CITY OF AUSTIN

APPLICATION TO THE RESIDENTIAL DESIGN
AND COMPATIBILITY COMMISSION (RDCC)

GENERAL MODIFICATION WAIVER

CITY OF AUSTIN – PLANNING AND DEVELOPMENT REVIEW DEPARTMENT
RESIDENTIAL PLAN REVIEW APPLICATION – MASTER COMMENT REPORT

SITE PLAN

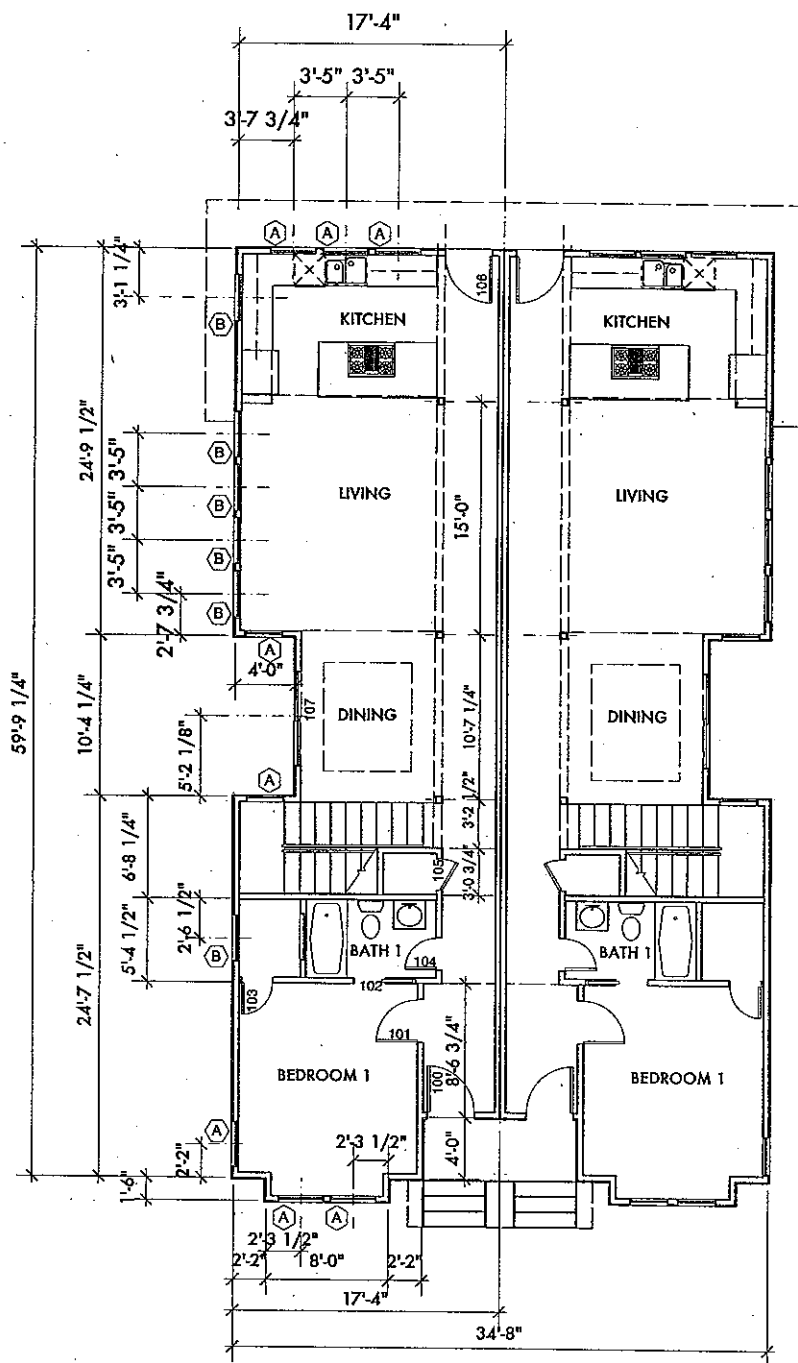
1. The gravel parking surface in the rear outside of the detached garage is not a surface approved by transportation for a legal parking surface. Only solid surfaces can be used for legal parking spots. You will need to pave that entire area. This will not increase impervious coverage, however, given that gravel is counted at 100% as well.

3. All the high points of each tent on the site plan are not the highest points. Please correct and call out the highest point of the 4 intersecting points for each 40 foot tent section.

Response: The parking area has been changed to concrete pavement.
2. The ribbon strips leading to the parking surface will need to be at least 3 feet wide with 2 feet in between. You have designed them the opposite way. This will add approximately 198 square feet to your impervious coverage figure. By my estimation, this will place your proposed IC at 47.34%, well over 45% max. Redesign or seek a BOA variance. You can also talk with transportation and see if they will allow a waiver to keep the ribbon strips at 2 feet. Another option is to make the rear parking area outside the garage smaller

Response: The ribbon strips have been adjusted to 3 feet with 2 feet in between. The overall impervious cover will be 44.7% based upon a redesign of the duplex.

Response: The elevations have been corrected. See sheet A1.0.
4. On the elevations, you have averaged the high points for some reason. The elevations should have the same exact high points that are on the site plan. For example, for tent section , the highest point is 665.3. This should be called out on both the site plan and the elevations. This is the elevation that the tent starts at for the entire tent section. Each section has a different tent high point, for example tent 2's high point, according to the site plan is 666.'

Response: The high points have been corrected. See sheet A1.0
